## Interim Progress Report

Nor-Lake Inc.  
891 Hwy U  
Hudson, WI  
BRRTS # 02-56-00089

This Interim Progress Report provides information in response to the Wisconsin Department of Natural Resources' (WDNR) *Case Closure under Wis. Admin. Code ch. NR 726 Not Recommended* letter dated September 29, 2020 (WDNR Response Letter). Information presented in this report includes results from the Sub-Slab Vapor Investigation which supplements or supersedes information presented in Ayres' *Sub-Slab Vapor Investigation Report* dated December 2019, evaluation of the potential for 1,4-Dioxane at the site, and an update on routine maintenance activities to be completed in 2021 on some of the remaining 40 active residential carbon filter units.

B.4.a. Vapor Intrusion Map  
Nor Lake Inc.  
Hudson, WI  
Revised January 2021

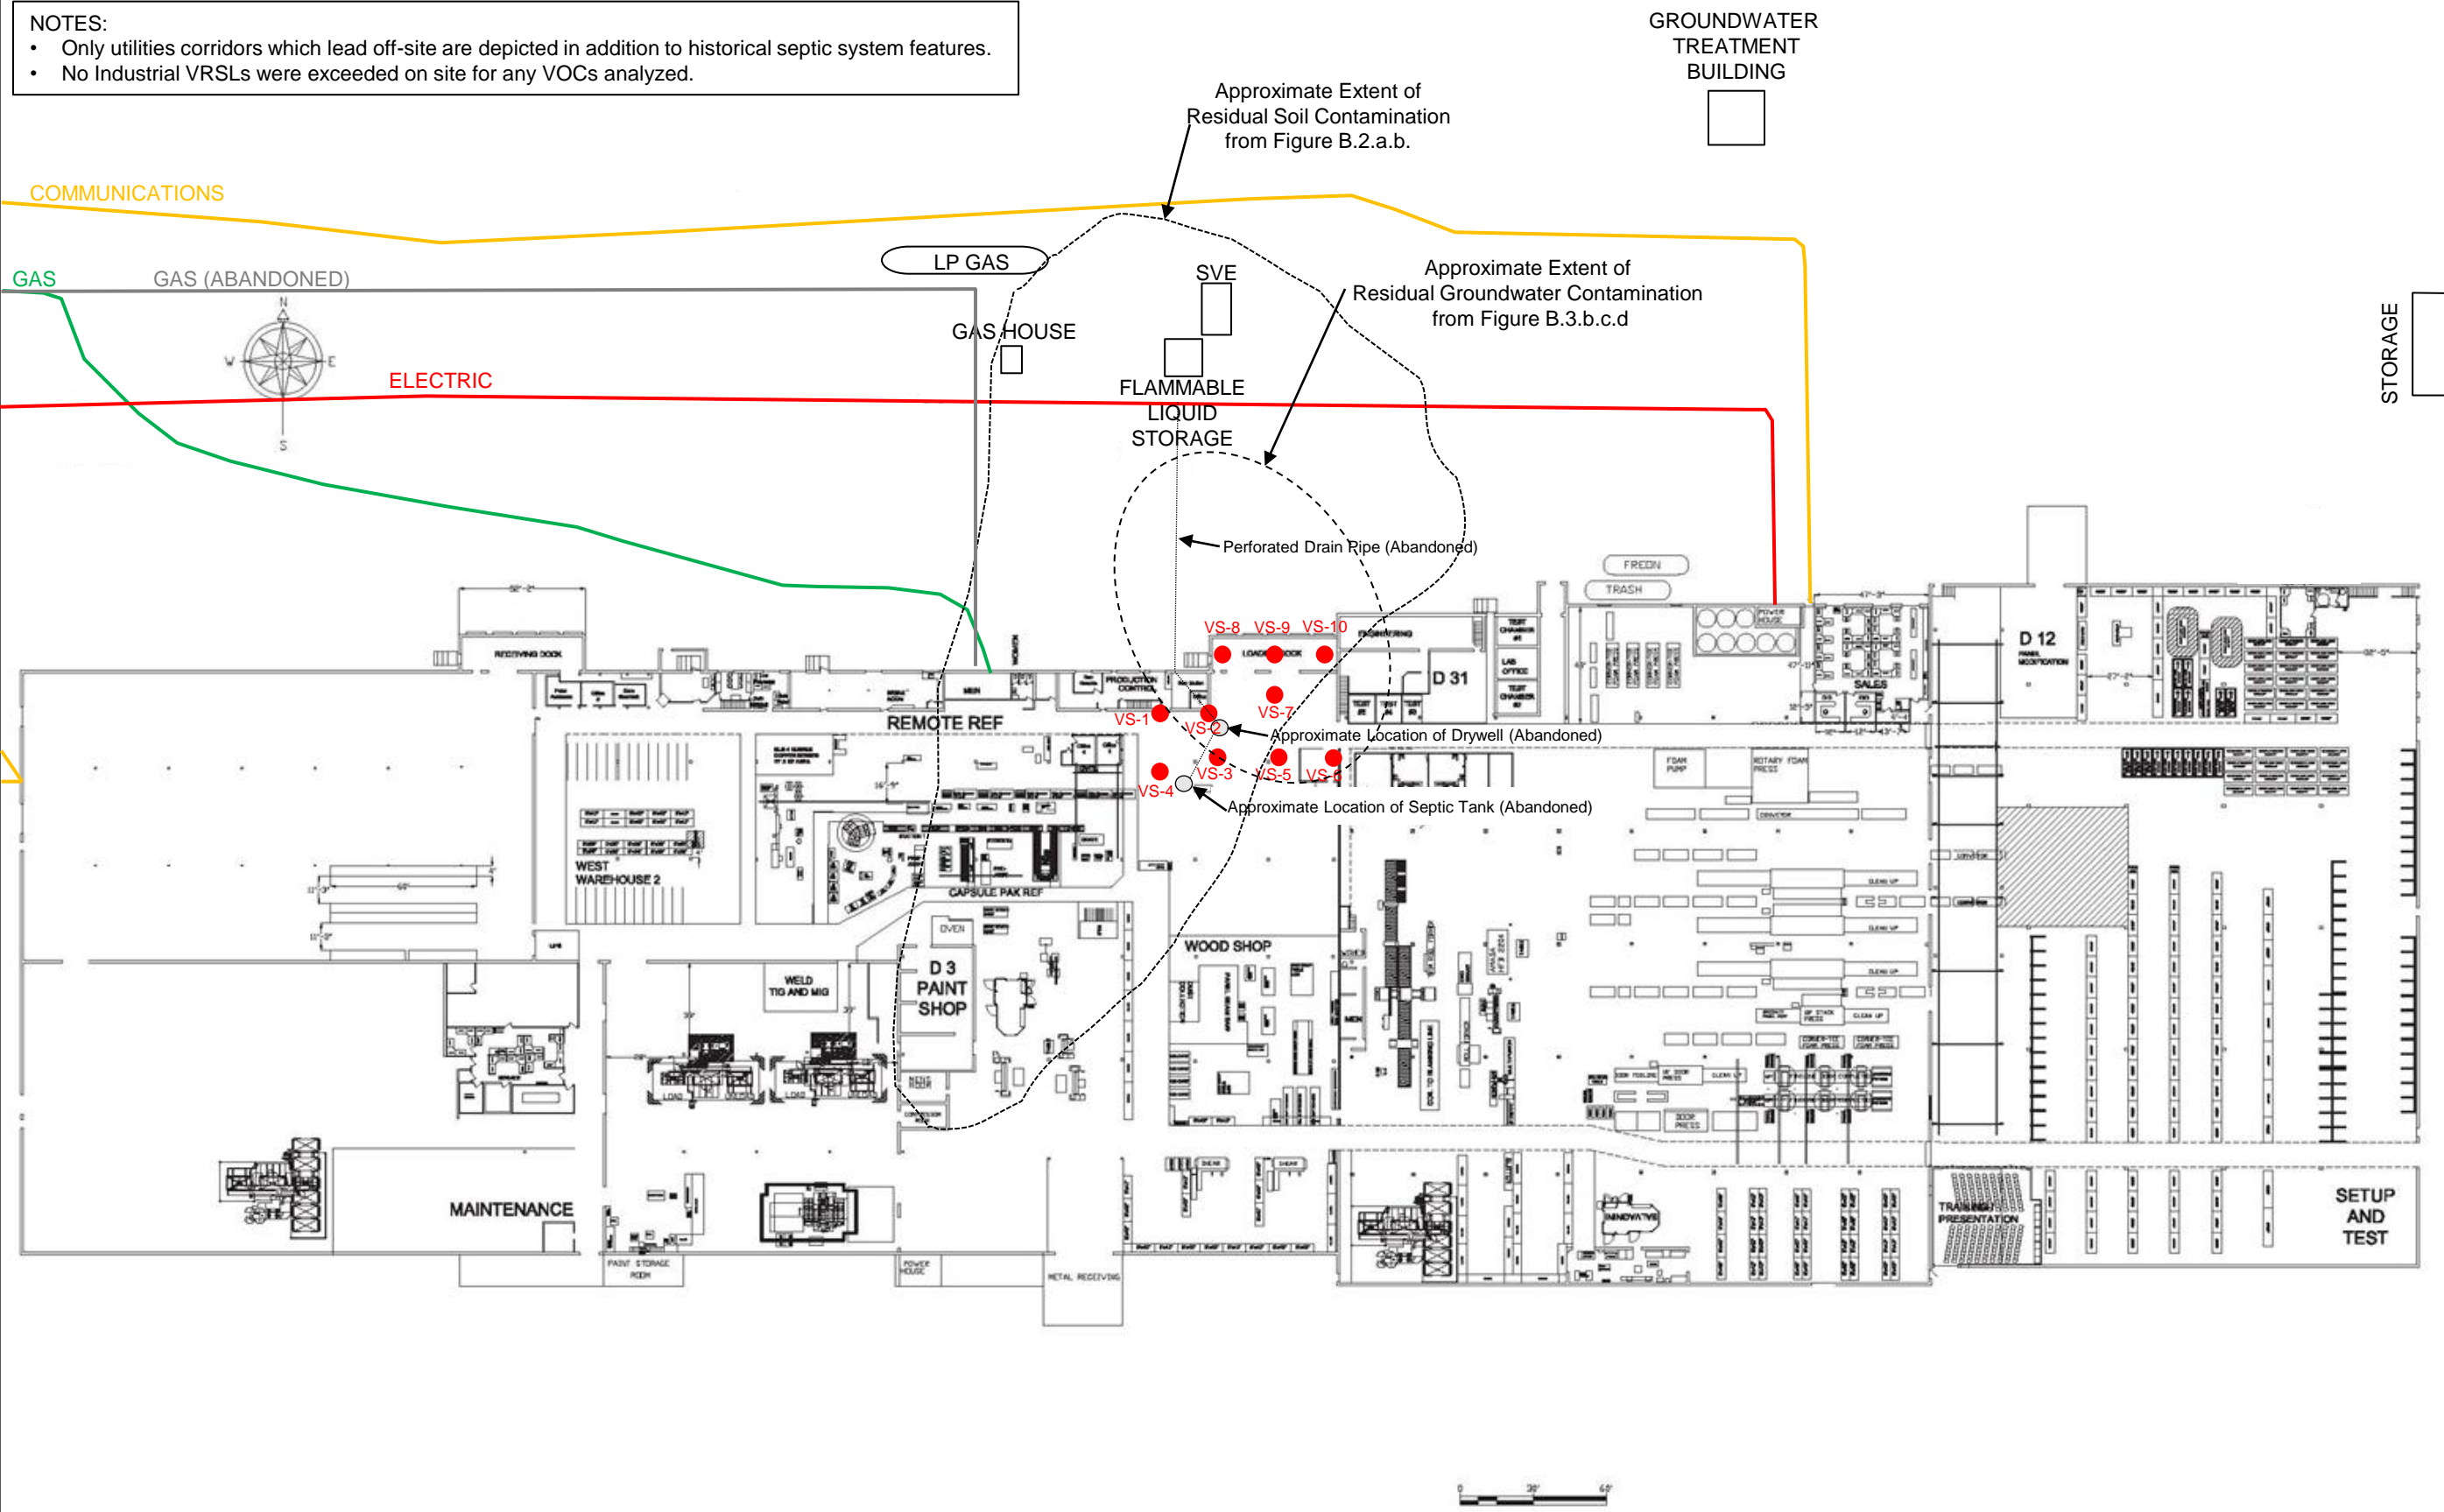
The black dots and triangular lines with distances from Figure 2 in the December 2019 vapor report have been omitted from the most recent vapor drawings because they are not necessary as supporting information. The black dots represented soil borings and were originally depicted on the Figure 1 Site Plan in the September 1992 Work Plan for the soil vapor extraction system. However, the current figure (Appendix B) depicts the same layout of the former septic system features, namely the septic tank, dry well, and associated perforated drainpipe.

Samples VS-1, VS-2, and VS-7, along with all other sub-slab vapor samples, were collected from the open manufacturing area and loading dock area. The locations of VS-1 and VS-2 are approximately six inches away from walls which divide the office area from the open manufacturing area. Although, no sub-slab vapor samples were collected from the adjacent office space, the results from VS-1 and VS-2 samples are representative of sub-slab vapor levels beneath the office area given their proximity (within one foot) to the office walls. The attached revised Figure B.4.a (Appendix B) depicts these sample locations after being recently verified.

In December 2020, Ayres evaluated the potential for vapor migration conduits by working with public and private utility locating services to map corridors that intersect the vapor source area and then network off-site. Such utilities include only unlikely conduits such as natural gas, electric, and communications lines (not larger storm or sanitary sewers). The attached revised Figure B.4.a depicts these public network utility corridors in addition to estimated extents of soil and groundwater impacts. As depicted in the figure, there are no known areas in which the industrial TCE VRSL is exceeded in sub-slab vapor.
